TO: Derek Case, PE MS 47354 / 360-705-7826
THRU: Paul Johnson, PE NB82-230 / 206-805-2920
FROM: Andrew P. Walter, PE NB82-230 / 206-805-5452
SUBJECT: 007999 – SR99 Bored Tunnel Alternative Design-Build Project
Federal-Aid No. BR-NH-STP-STPF-0099(111)
CO 203 R1 – PCO 640, SURFACE TEXTURING

Attached for HQ execution is Change Order 203 R1, "PCO 640, SURFACE TEXTURING".

CONTRACT NO: 007999 FEDERAL AID NO: STP-BR-IM-0099 (11)
CONTRACT TITLE: SR 99, BORED TUNNEL ALTERNATIVE - DESIGN BUILD PRO
CHANGE ORDER NO: 203 RI PCO 640, SURFACE TEXTURING

Subject: SR 99 Bored Tunnel Alternative Design-Build Project
Contract No. 007999 / Federal-Aid No. BR-NH-STP-STPF-0099(111)
Request for Change Proposal – Roadway Surface Abrasion

SEC.30, T.25N. R.4E. W.M.

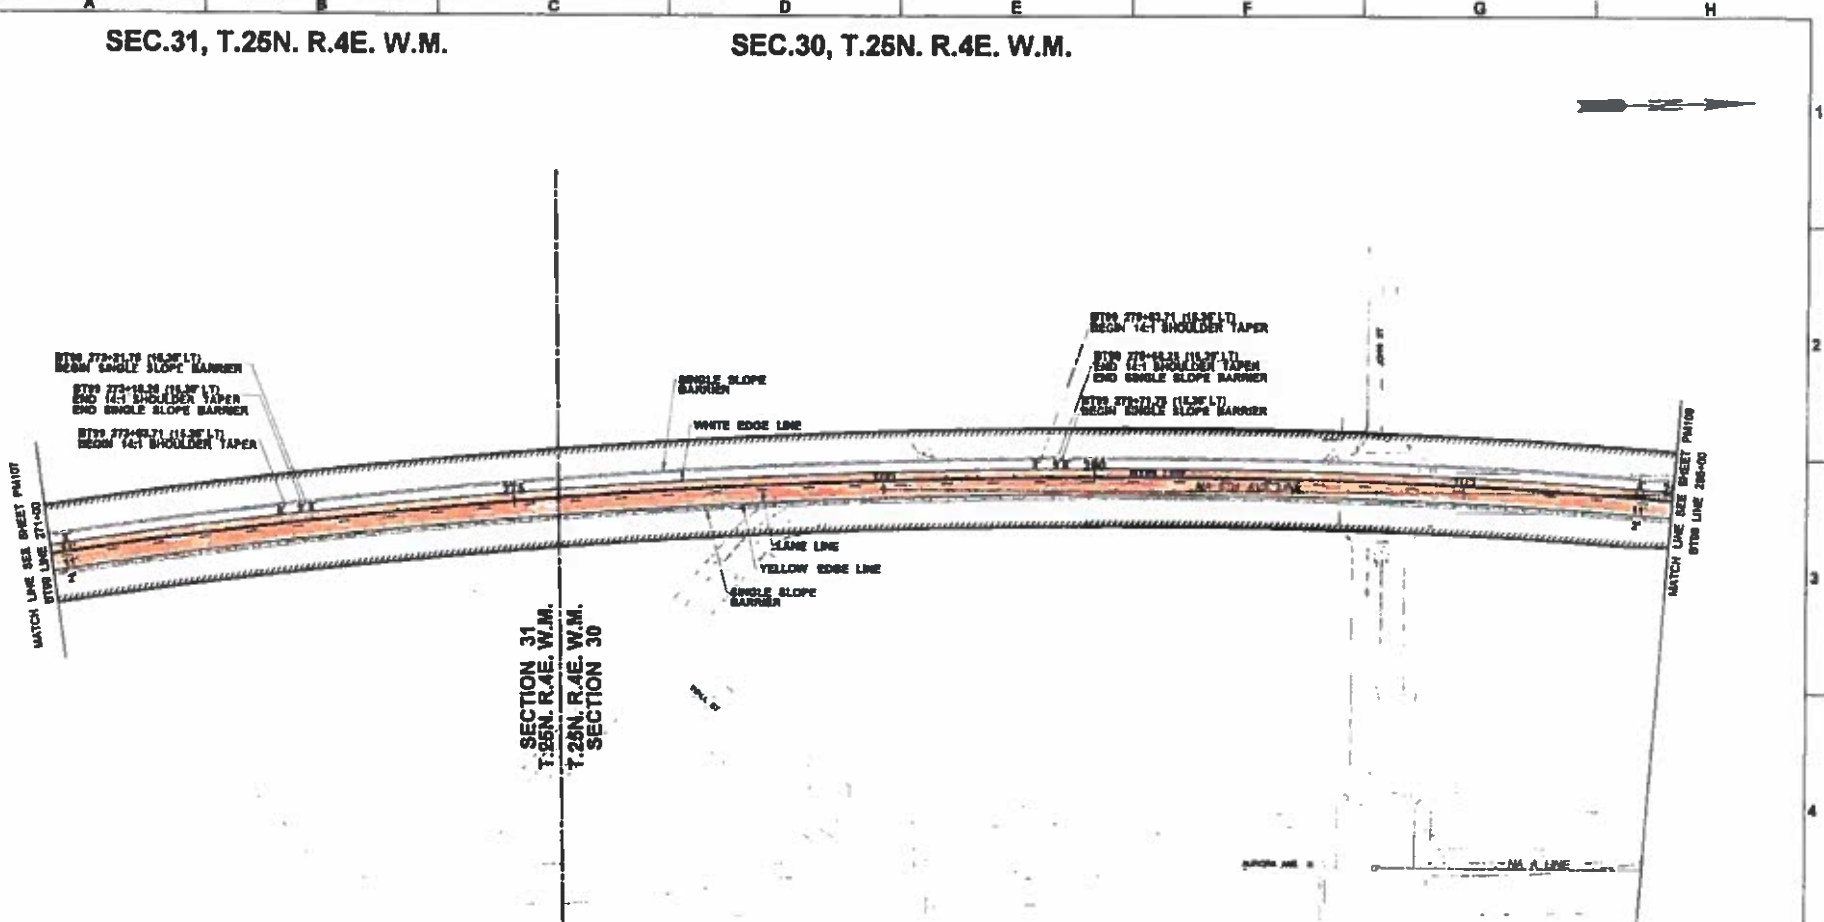
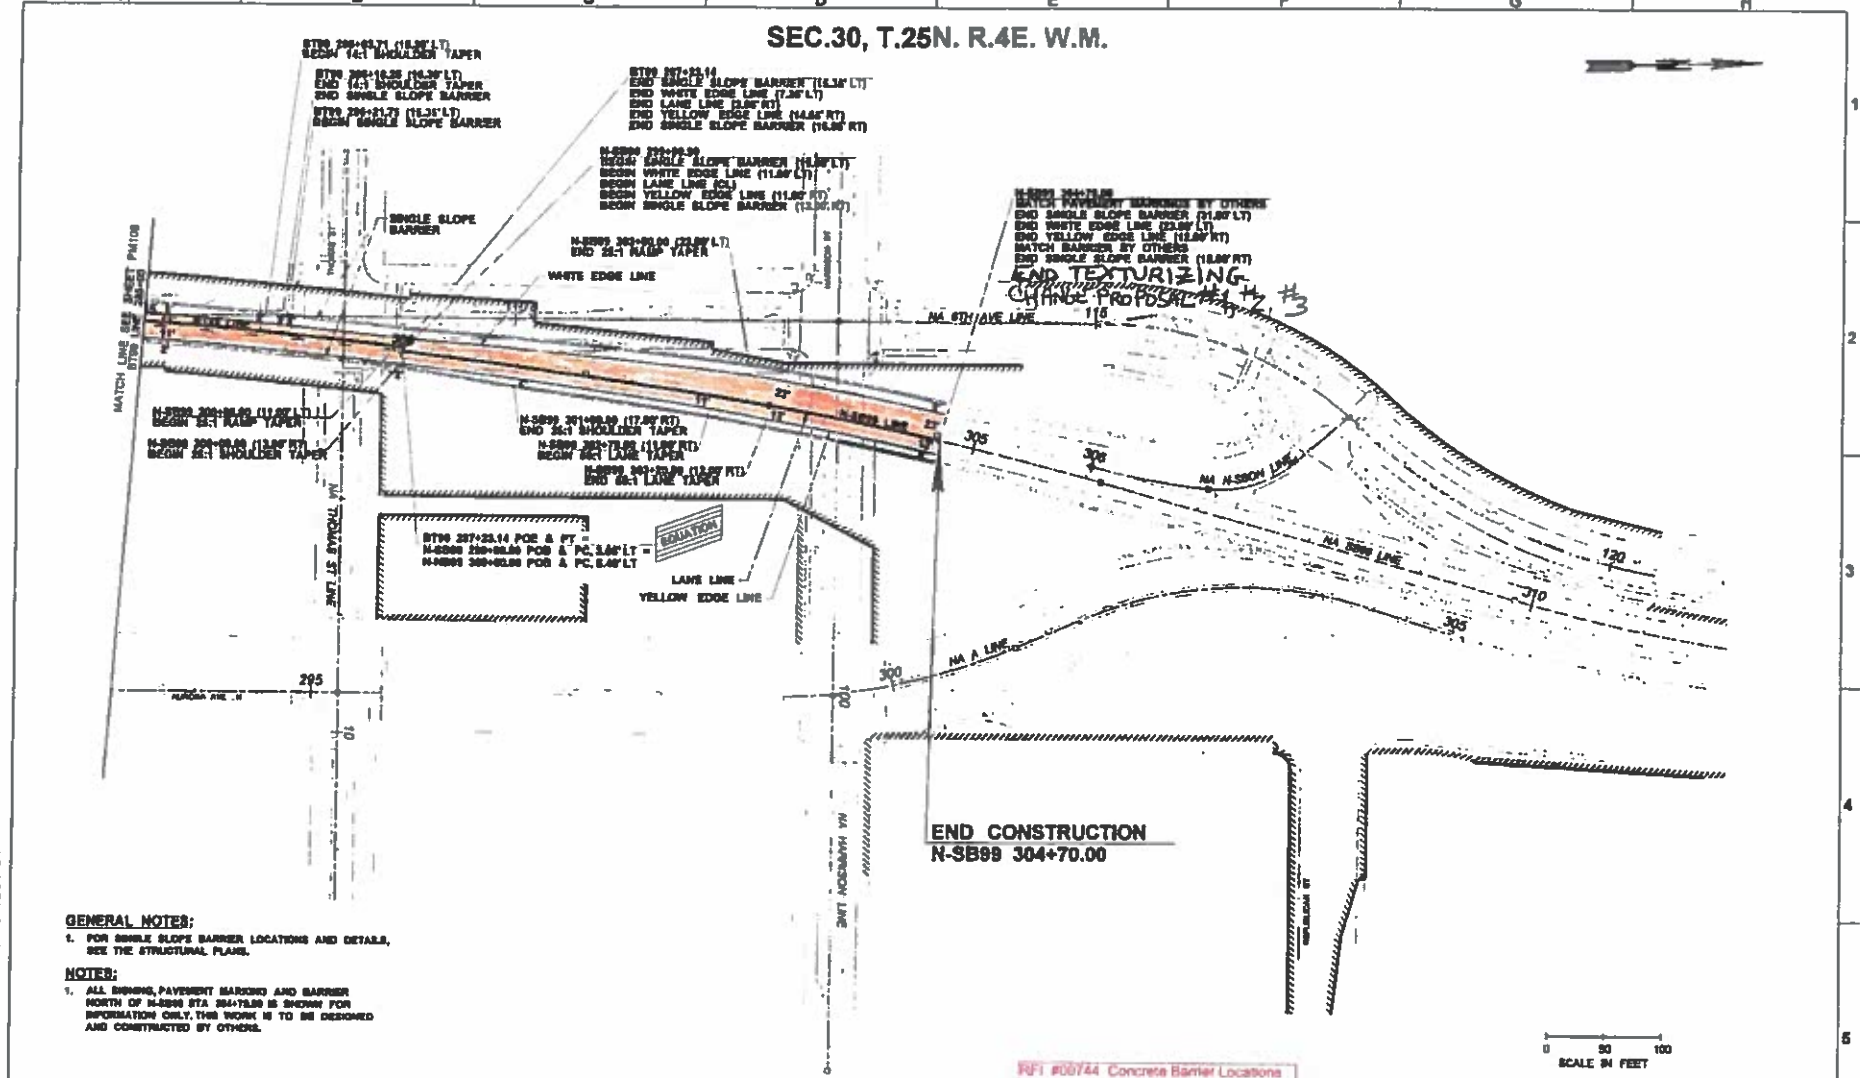
- NBOFF 304+50 to 304+63.89
- Texturize two 11-foot lanes, southbound tunnel, portal to portal, stations:
 - S-SB99 191+58.85 to S-SB 194+58.84 (match line with BT99 194+50)

- Southbound roadway BT99 194+50 to BT99 287+23.14 (match line with N-SB99 299+99.99)
 - N-SB99 299+99.99 to N-SB99 304+70
 - N-SB99 300+00, begin ramp taper to N-SB99 303+00 end ramp taper

- N-SB99 303+00 to N-SB99 304+70, 23' wide right lane
- Also texturize the 8-foot shoulder, both northbound and southbound (it is acceptable to limit texturing to 6-feet on shoulder)
